RESPONSE TO LANDSCAPE OFFICER COMMENTS

Thank you for the detailed landscape comments on the proposed floodlighting at Wide Lane Sports Ground (dated 28 March 2024). The information below responds to the queries raised. A significant amount of option testing and modelling informed the proposed design, so we hope that this information clarifies the justification for the design.

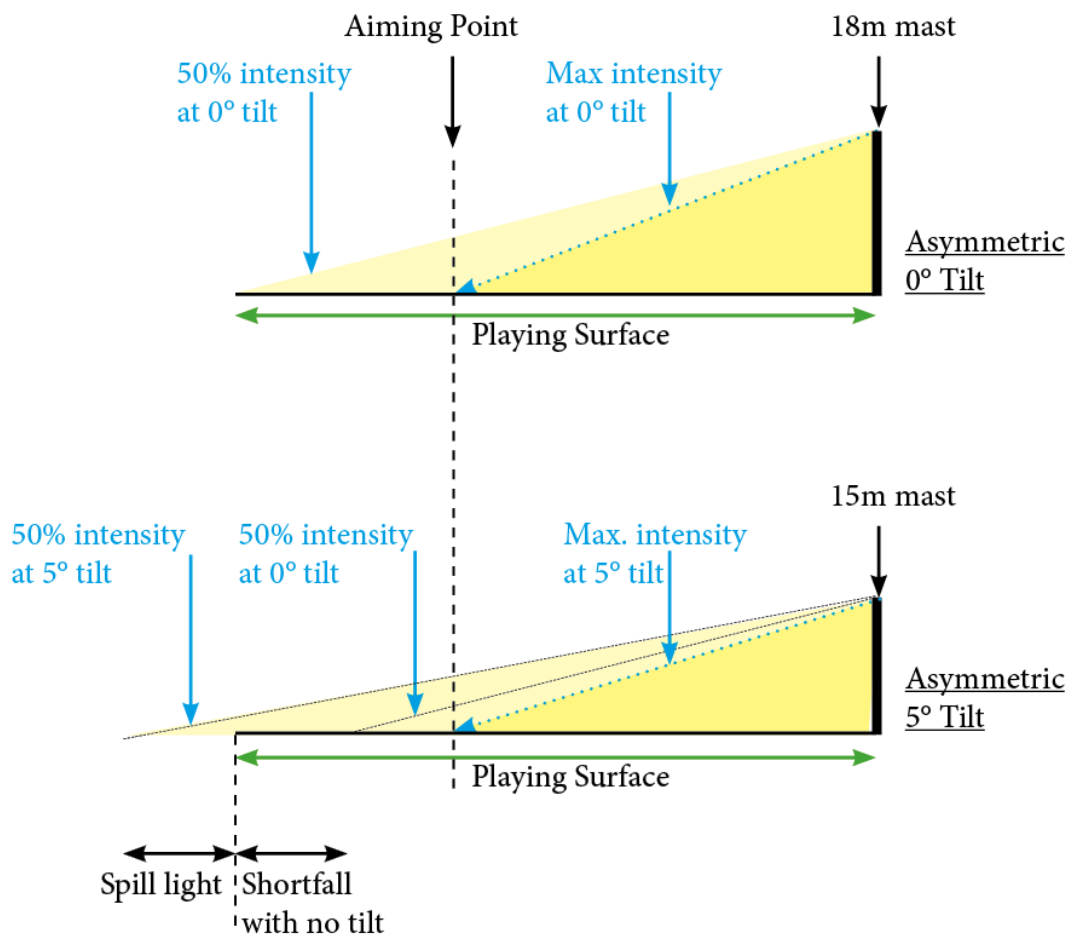
The existing temporary, diesel-powered floodlights used at the site have a maximum height of 9.14m and are of a similar style to the unit in the image below. Given the low height of these floodlights, they have a high tilt angle to ensure the light reaches across the pitches. As a by-product of this tilt angle, floodlights of this type produce a substantial amount of direct upward light pollution.

The key design driver for the proposed permanent floodlights is to reduce unnecessary light spill and have zero direct upward light. This will reduce the ecological impact and night-time visibility of the lighting. A range of mounting heights, including lower levels, were tested during the design of the proposed floodlighting. The proposed 18m height was determined to minimise both light spill and visual impact.

As shown in the image below, to achieve the equivalent lighting intensity across the pitch surface using 15m mast, the lighting units must be tilted. This generates light spill beyond the pitch and increased amounts of direct upward light.

In the specific context of the application site, any unnecessary light spill would cause lighting of the surrounding trees and would be unacceptable from an ecological point of view. The 18m masts allow for zero tilt on the lighting units, minimising light spill. This reduction of light spill will also benefit the night-time views.
